LICENSEE: Indiana Michigan Power Company
FACILITY: Donald C. Cook Nuclear Plant, Units 1 and 2
SUBJECT: SUMMARY OF OCTOBER 14, 2009, CATEGORY 1 PUBLIC MEETING TO DISCUSS RESPONSES TO GENERIC LETTER 2004-02 REQUESTS FOR ADDITIONAL INFORMATION (TAC NOS. MC4679 AND MC4680)

NRC – Donald C. Cook Nuclear Plant Public Meeting

**Containment Recirculation
Sump Performance**

Containment Recirculation Sump Performance
Debris/Flow Split RAI Support

System Head Loss Vs. Debris Split
for Debris Load Equivalent to 360% of Total Available Debris

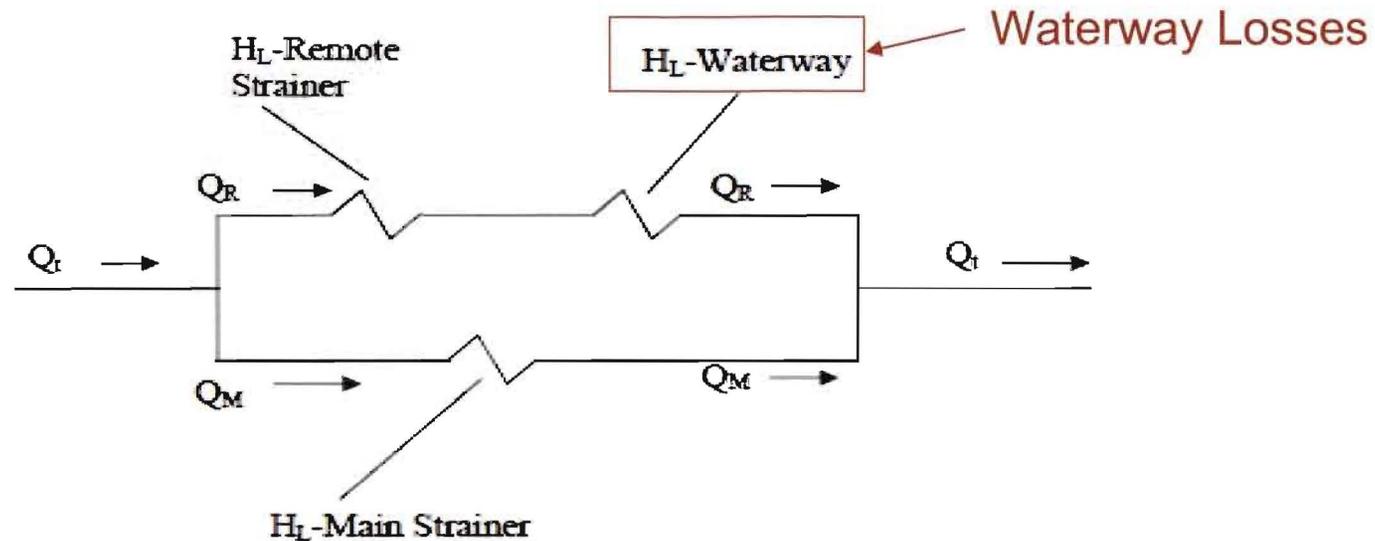
- Head Loss increases with percentage of debris load allotted to the main strainer
- Why?

- As more debris is allotted to accumulate on the main strainer, the flow rate increases through the remote strainer flow path and reduces through the main strainer to maintain equivalent system head loss.
- Increased flow rate through the remote strainer path increases head loss from the waterway.
- Increased debris on the main strainer causes increased flow through the remote strainer path. Increased flow through the remote strainer path causes increased system head loss due to the presence of the ductwork/waterway.

- System Head loss increases as the debris split favors loading on the main strainer due to the waterway losses associated with the remote strainer flow path.
- Any event which would result in more debris reaching the remote strainer would only reduce system head loss by relieving the debris available to load on the main strainer.
- The quantity of main strainer debris tested exceeds the total available quantity of debris

Marinite on Cable Tray Before Test

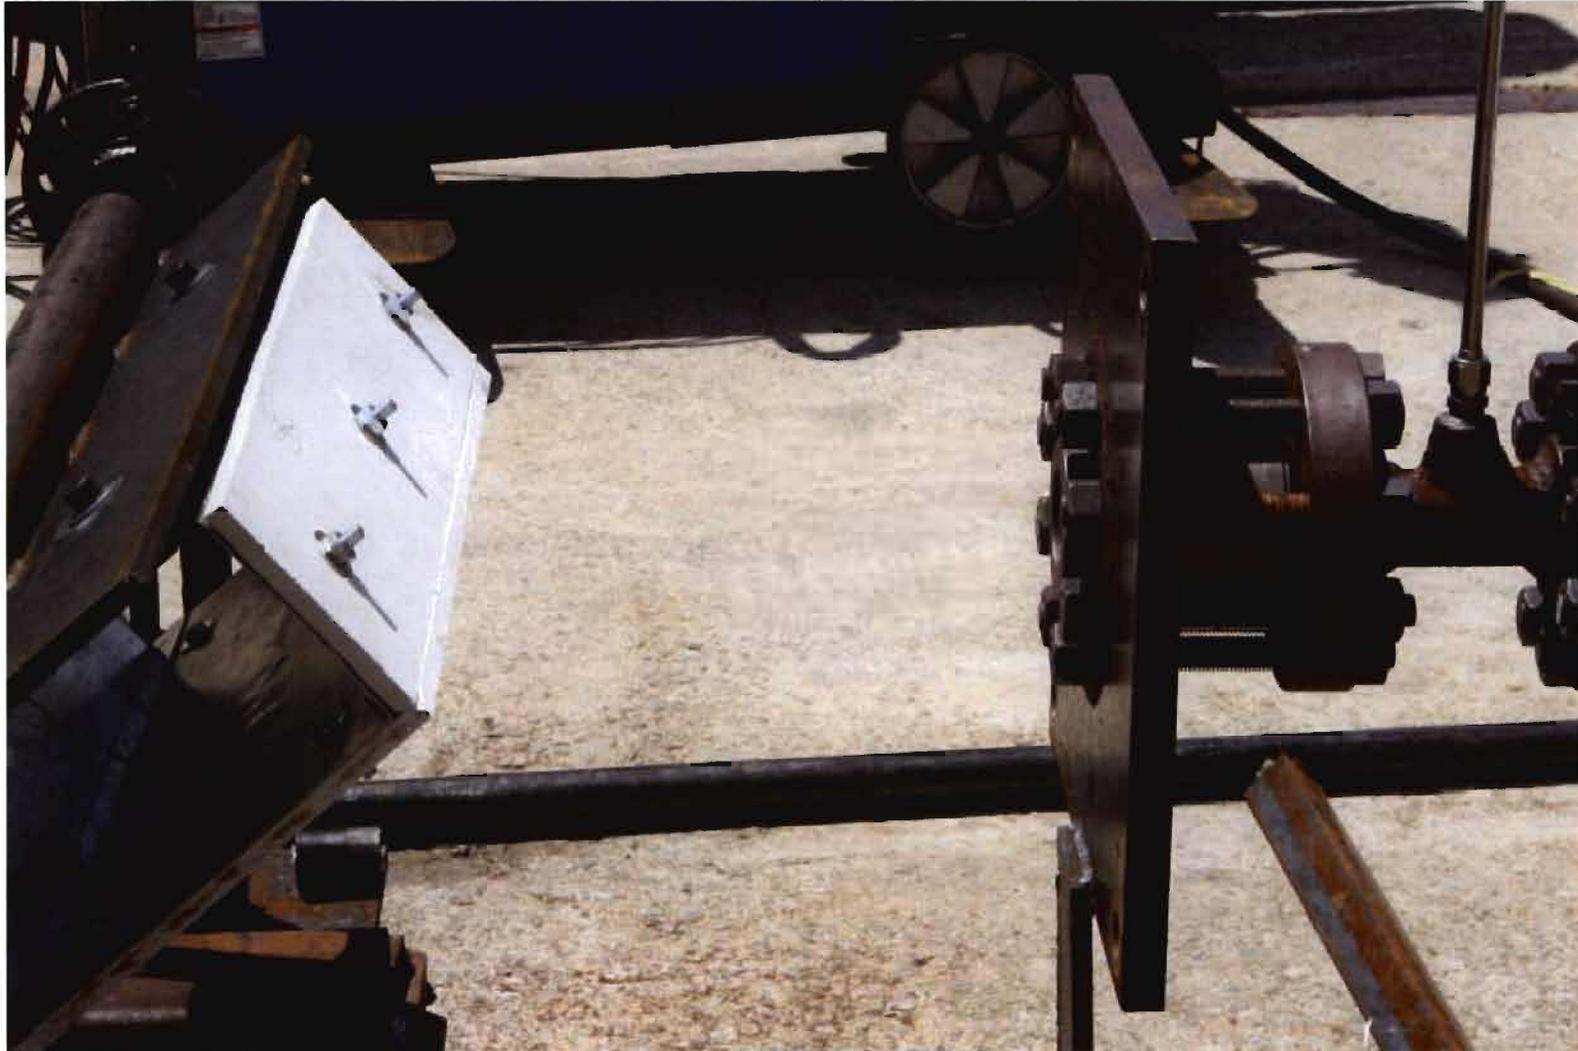
- One of the generic questions associated with two-phase jet testing of materials is the effect of the radial decay of pressure away from the jet centerline
- For Cook, the failure mechanism that resulted in debris generation of Marinite board debris was the physical deformation of the unsupported and unrestrained cable tray section that was tested
 - As the cable tray deformed, a lever was applied between the face edges of the Marinite that was attached to the cable tray
- NUREG/CR-6772 established a destruction pressure of 64 psi (a ZOI of $\approx 3D$) for Marinite which is the pressure at which damage starts to occur
- The Marinite that is closest to a bounding break location is $\approx 4D$

- As can be seen in the pictures on the next two slides, the cable tray that was tested at a ZOI of $\approx 3.4D$ was deformed to the point that further destruction could not reasonably occur
- For conservatism, the quantity of debris generated from the breaks that resulted in debris generation (a ZOI of less than $5.5D$) was applied to all Marinite installations out to a ZOI of $9.8D$
- The total quantity of Marinite available for debris generation is just a small fraction of the total particulate debris sources available ($\approx 0.1\%$)

I&M judges that the effects of radial decay had insignificant impact on the total quantity of Marinite debris assumed to be generated

Average velocity in non-transport regions for small pieces of Cal-Sil and Marinite

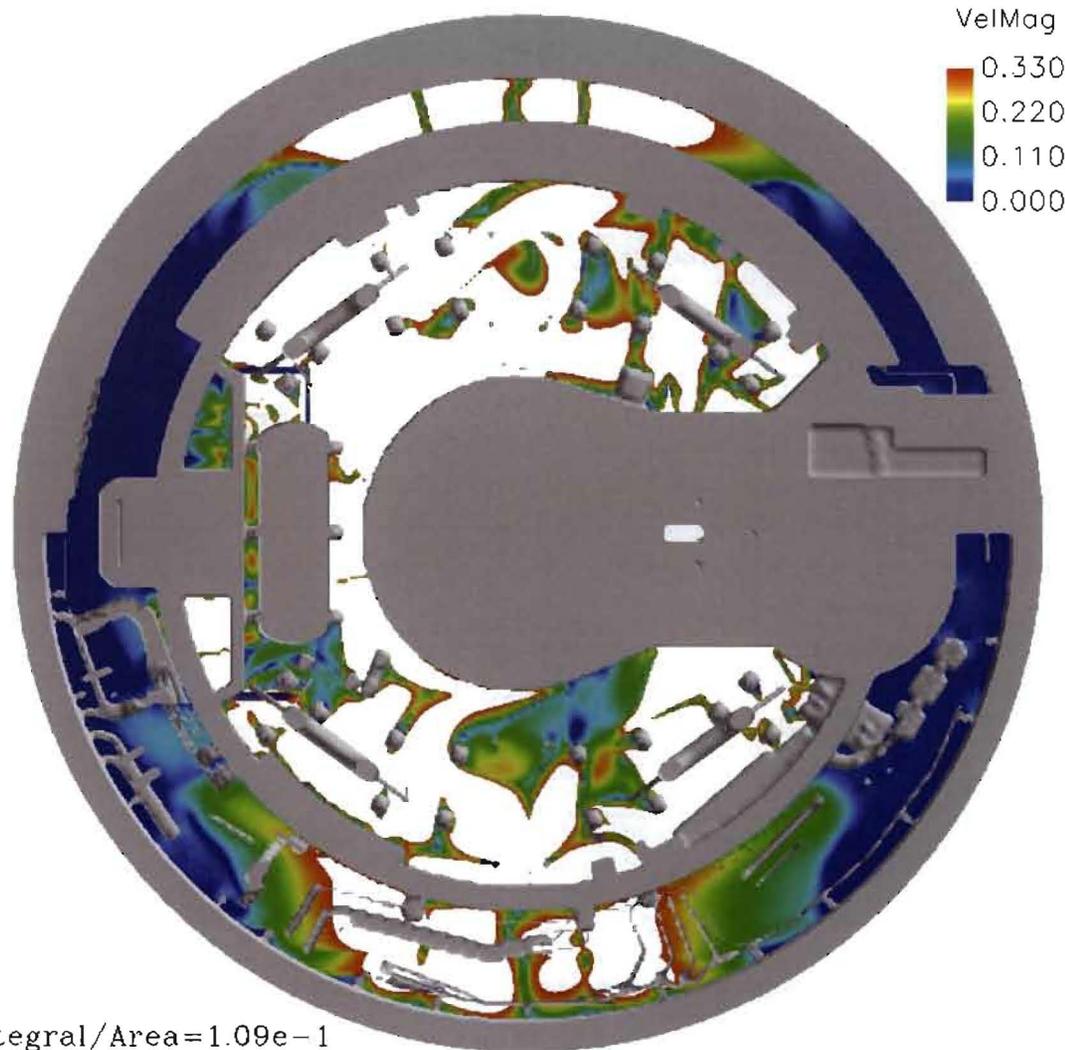
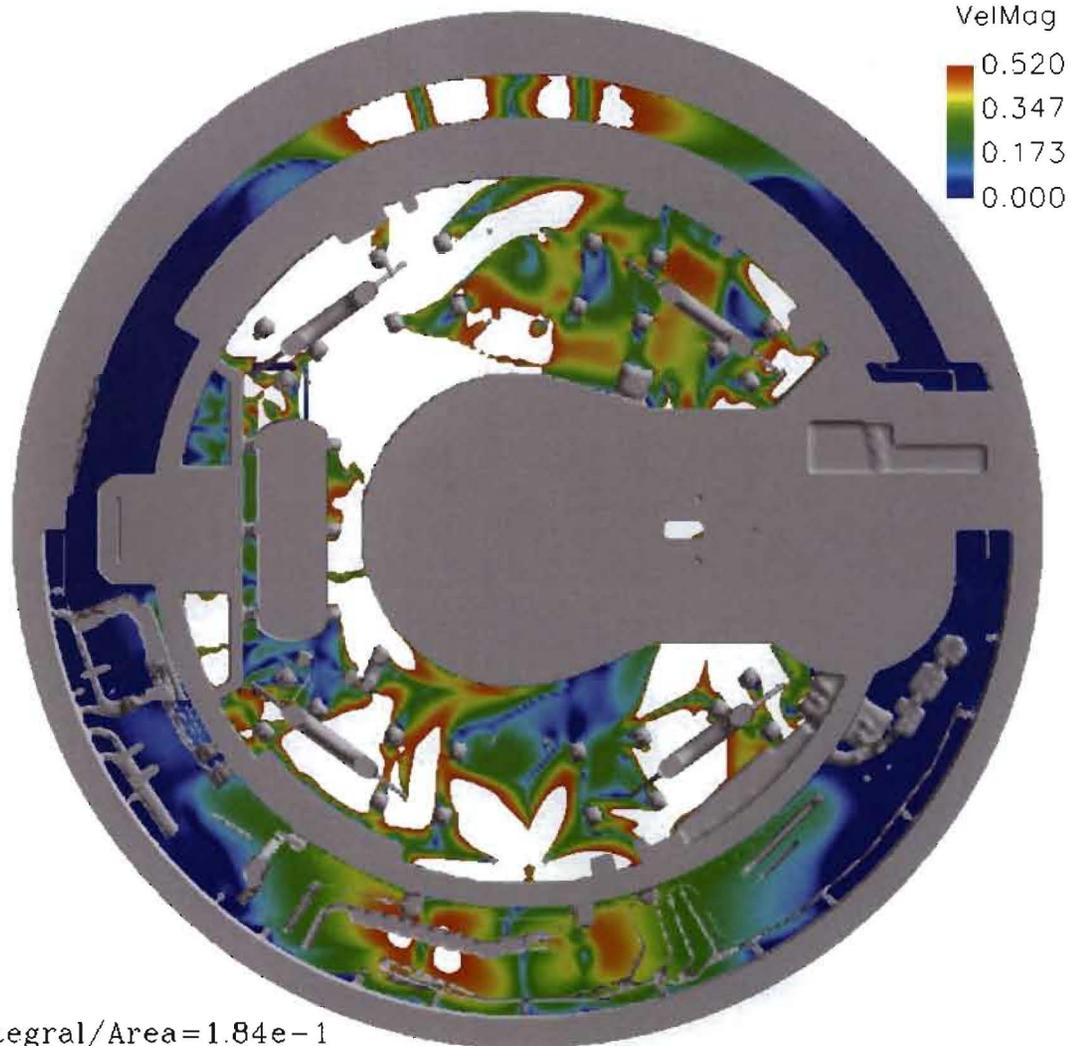
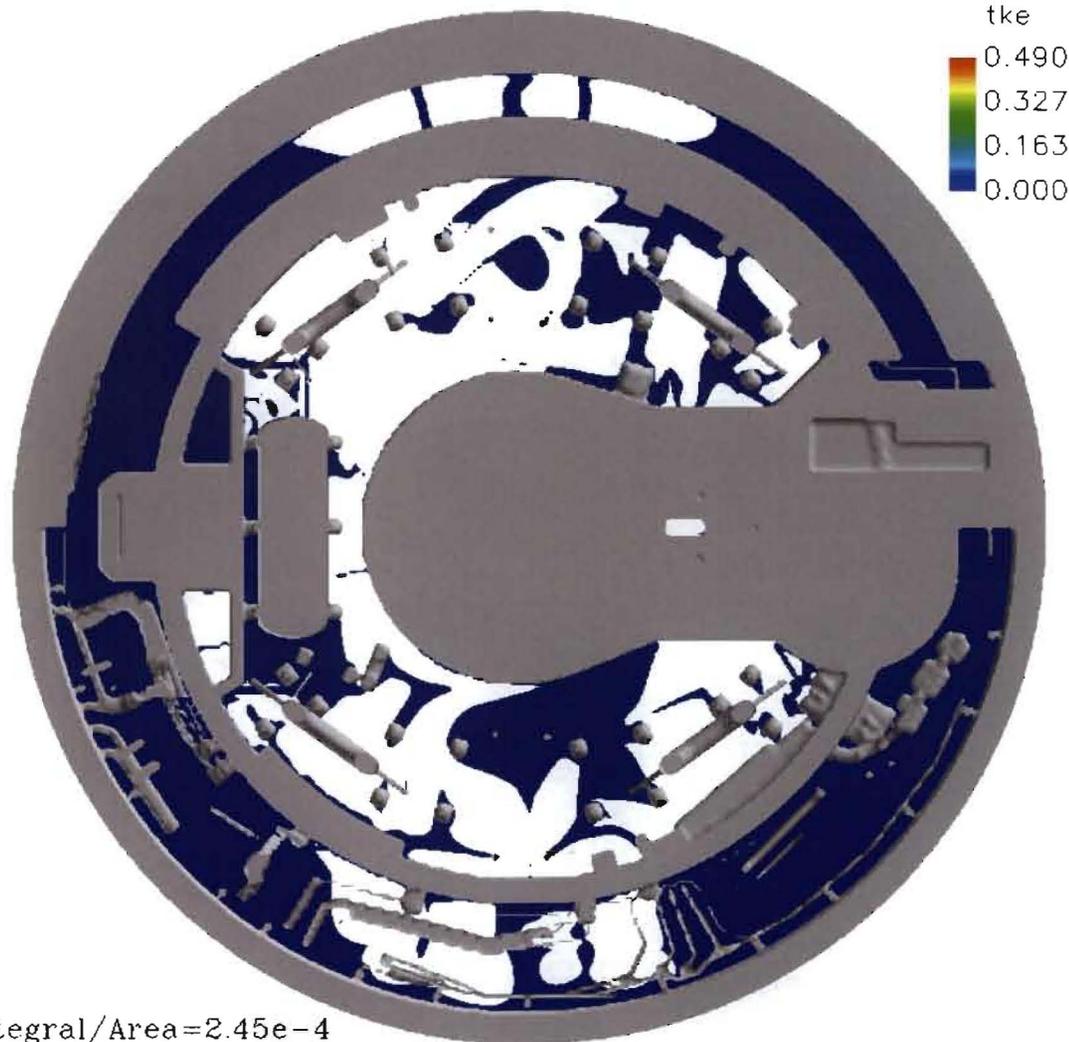
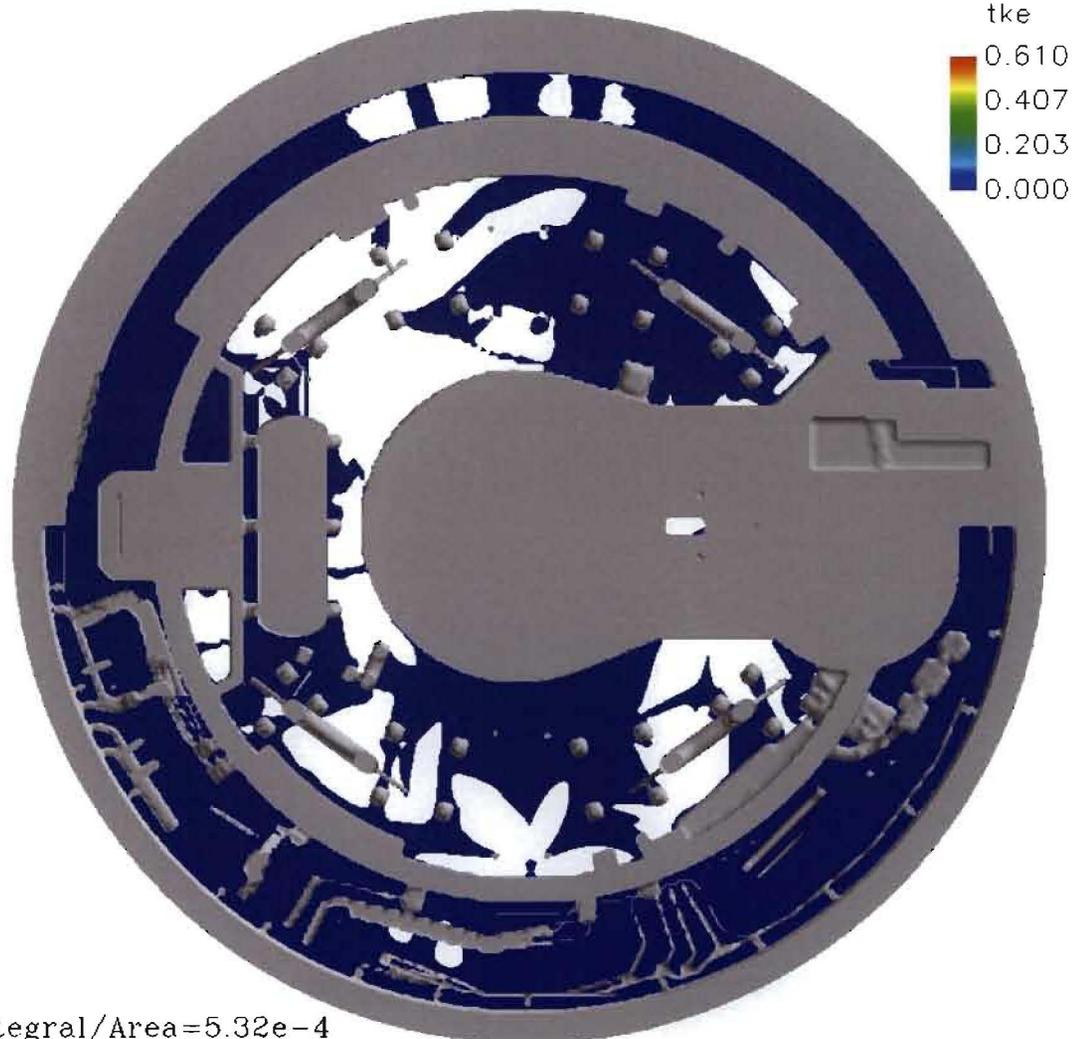
- The test velocity was >2 (~2 to 3) times greater than the average pool velocity for the non transporting portions of the pool that the erosion factor was applied to.
- The pool TKE is insignificant (3 to 4%) as compared to the pool kinetic energy
- The test kinetic energy is >4 (4 to 13) times the pool kinetic energy.
- The fact that the samples obstruct a portion of the test flow area causing higher velocities is additional conservatism.
- Although the exact TKE level in the tests is not known, the velocity is high enough for turbulence to occur.

- The test velocity was >2 (~2 to 3) times greater than the average pool velocity for the non transporting portions of the pool that the erosion factor was applied to.
- The pool TKE is insignificant (3 to 4%) as compared to the pool kinetic energy
- The test kinetic energy is >4 (4 to 13) times the pool kinetic energy.
- The fact that the samples obstruct a portion of the test flow area causing higher velocities is additional conservatism.
- Although the exact TKE level in the tests is not known, the velocity is high enough for turbulence to occur.
- Therefore, it can be reasonably concluded that the flow conditions in the erosion test were conservative without doing extensive additional analysis to calculate the test TKE.
